DETROIT HISTORIC DISTRICT COMMISSION REGULAR MEETING

Date: August 12, 2020

Existing

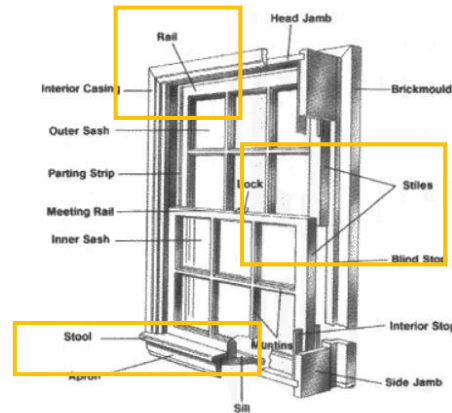
The applicant did not submit dimensions of the existing and Pella window sash so a precise comparison to the window openings was not completed. The application did include a comparison of glass area per sash for a 33" x 69" window (full frame):

Reduction of glass width in replacement window:
1 inch = 3.44% decrease
Reduction of glass height in replacement window:
2 inches = 3.25% decrease

- The existing brick mould will be retained; it will not be covered with coil stock.
